QUALITY ASSURANCE -- NON-CONFORMANCE REPORT

Location: Changxing Island, Shanghai, P.R. China **Report No:** NCR-000758
Prime Contractor: American Bridge/Fluor Enterprises, a JV **Date:** 09-Jun-2010
Submitting Contractor: Zhenhua Port Machinery Company, Ltd (ZPMC), Changxing Island **NCR #:** ZPMC-0720

Job Name: SAS Superstructure

Subject: NCR No. ZPMC-0720

Reference Description: QC Missed (1) Transverse Indication found on weld number: FB3106-001-040 by QA

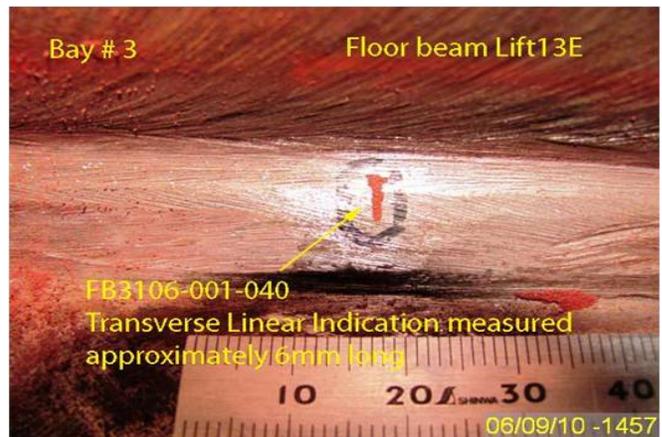
During the Quality Assurance (QA) Magnetic Particle Testing (MT) review of weld located on Floorbeam Sub Assembly FB3106A for 13AE, QA discovered the following issue:

- One (1) Transverse indication measuring approximately 6mm in length.
- The weld is a fillet T-joint joining the Stiffener to the floor beam web.
- The weld is identified as FB3106-001-040.
- The indication is clearly marked on the material near the weld.
- OBG Floor beam FB3106-001 is located in bay 3.

The Notice of Witness Inspection Number (NWIT) is 005939. The indication is located within an area that has been previously tested and accepted by ZPMC Quality Control (QC) personnel.

AWS D1.5 (02) Section 6.26.2 – "Welds that are subject to MT in addition to visual inspection shall have no cracks."

Reference Resolution: ZPMC has repaired the indication and is providing NDT to show that the weld is acceptable. . ZPMC has written and internal NCR.

This proposed resolution is acceptable. The documentation received is sufficient and the Department concurs that Non-Conformance ZPMC-0720 is closed.

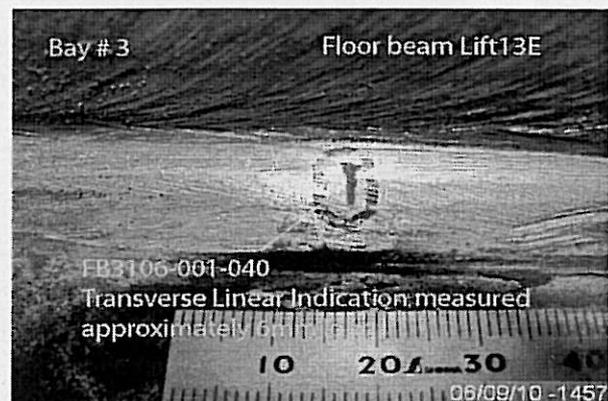
During the Quality Assurance (QA) Magnetic Particle Testing (MT) review of weld located on Floorbeam Sub Assembly FB3106A for 13AE, QA discovered the following issue:

- One (1) Transverse indication measuring approximately 6mm in length.
- The weld is a fillet T-joint joining the Stiffener to the floor beam web.
- The weld is identified as FB3106-001-040.
- The indication is clearly marked on the material near the weld.
- OBG Floor beam FB3106-001 is located in bay 3.

The Notice of Witness Inspection Number (NWIT) is 005939. The indication is located within an area that has been previously tested and accepted by ZPMC Quality Control (QC) personnel.

Repair said indication and perform NDT required to verify weld quality.

Contractor supplied post repair NDT documentation verifying weld conforms with Contract weld quality requirements. An internal NCR was also issued by ZPMC in regards to this issue.
